stm32-blinky — Design Document

Board review: stm32-blinky (P8 adversarial pass)

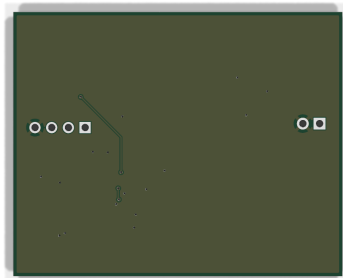
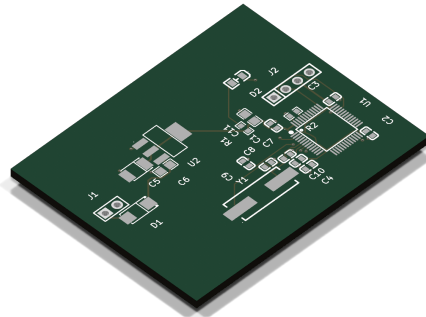
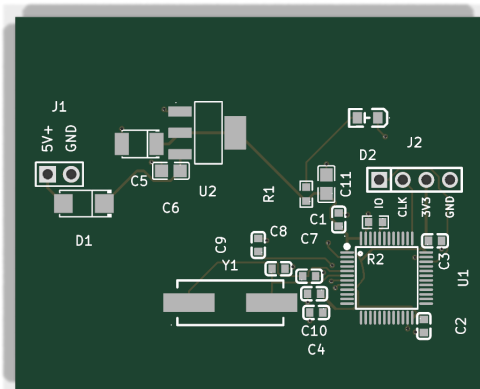
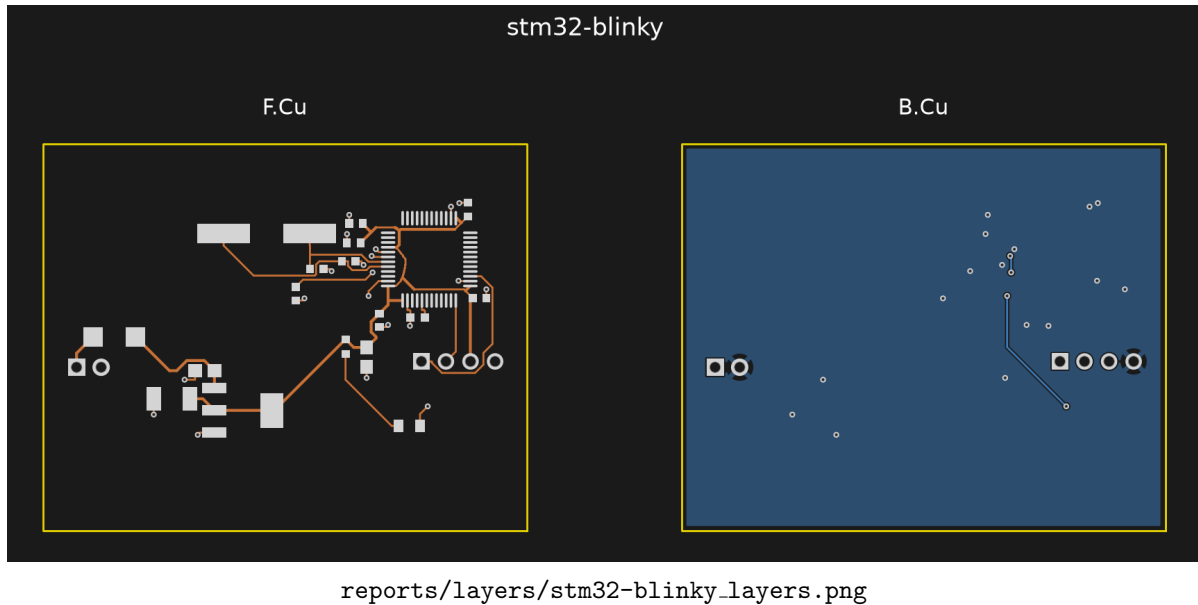
ERROR 1 - J1 power input has no polarity legend on silk (requirements miss)

requirements.md sec 2 and architecture/blocks.md both promise the 5 V input "polarity marked on silkscreen" (J1 pin 1 = +5 V, pin 2 = GND). The as-built board has NO text or +/- legend anywhere: silk carries refdes only (there is not a single gr_text on the board). What exists at J1 is a pin-1 dot and a square pad (see crop-j1_d1.png) - and the dot sits on the header body outline,

so after the header is soldered the plastic covers it. Post assembly the top side shows nothing but "J1"; the square pad is visible only from the bottom.

Consequence: the unkeyed 2-pin input can be plugged backwards with no on-board hint. D1 (series SS34) prevents damage - reversed input just does not conduct - but the user gets a dead board and no way to know why or which way is right without opening the design files. This is the board's primary human interface and an explicit requirements promise. Fix is two silk texts ("5V", "GND" or "+", "-") next to the holes, outside the header body. Must fix before fab; there is ample empty silk area (left region is empty).

WARNING 1 - J2 SWD pins unlabeled (architecture promise miss)

`blocks.md` promises "Canonical pin order (silk-labeled): 1 = SWDIO, 2 = SWCLK, 3 = 3V3, 4 = GND". Electrical order verified correct from the netlist (pads: SWDIO/SWCLK/+3V3/GND, U1 PA13/PA14 to pins 1/2). But there are no labels - only a pin-1 square cell (`crop_d2_j2.png`) which the header body covers after assembly. ST-Link clones are wired pin-by-pin; swapping 3V3/GND shorts the debugger's 3.3 V rail to ground. Same trivial fix as ERROR 1 (four small silk texts below the header row - the area under J2 is clear). Strongly recommend fixing together with ERROR 1; warning rather than error only because `requirements.md` itself demands the ORDER (met), the labels are an architecture-level promise.

WARNING 2 - refdes association ambiguity (cap cluster + C3-under-J2)

- "C11" text sits directly above R1's body; "C1" text below-left of R1; "C7"/"C8" labels float between parts they do not touch. Among these 0603s are four DIFFERENT cap values (22 pF, 10 nF, 100 nF, 1 uF) plus a 1 k resistor - a hand-rework or debug probe guided by silk has a real chance of landing on the wrong part.
- "C3" text renders directly under J2 pads 3-4 and reads like a header label (its own body is 3.6 mm away). Mildly reinforces the J2 labeling problem: someone may read "C3" while counting SWD pins.
